8802-3/802.3 REVISION REQUEST

REQUESTED REVISION:
STANDARD: IEEE Std 802.3ab-1999
CLAUSE NUMBER: 40C.2.1 and Figure 40C-2
CLAUSE TITLE: Auto-Negotiation Transmit state machine add-on
for 1000BASE-T

Figure 40C-2 as modified by Revision requests 1042 to 1049 - Changes annotated

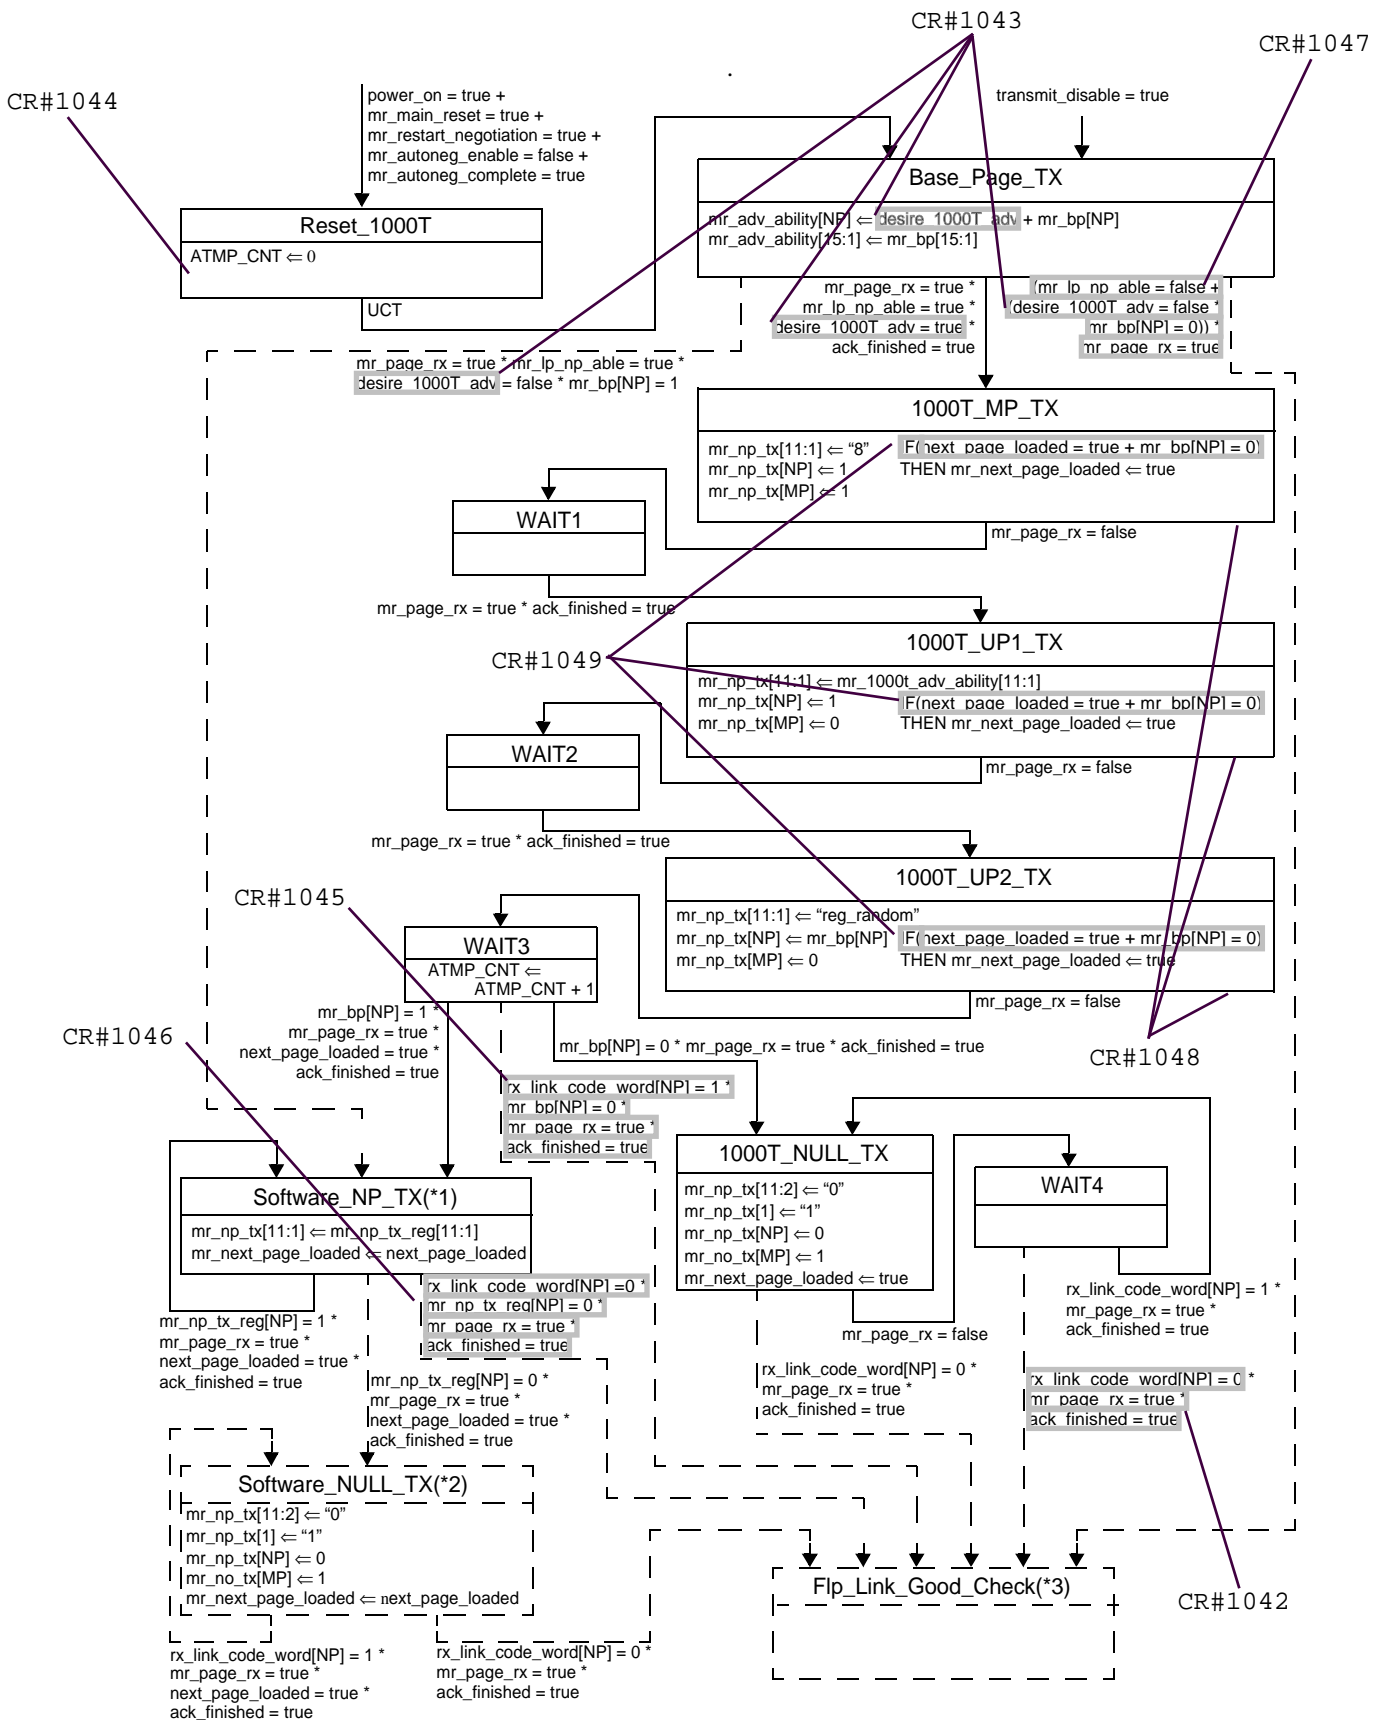
In Figure 40C-2 make a transition from WAIT3 directly to
Flp_Link_Good_Check with the following conditions:
rx_link_code_word[NP]=0 * mr_bp[NP]=0 * mr_page_rx=true *
ack_finished=true.

To be precise, rx_link_code_word[NP]=1 should be added to the transition
conditions between WAIT3 and 1000T_NULL_TX.

The WAIT3 state does not have an exit directly to Flp_Link_Good_Check.
There will be circumstances in which a device will not have to transmit a
null message page.
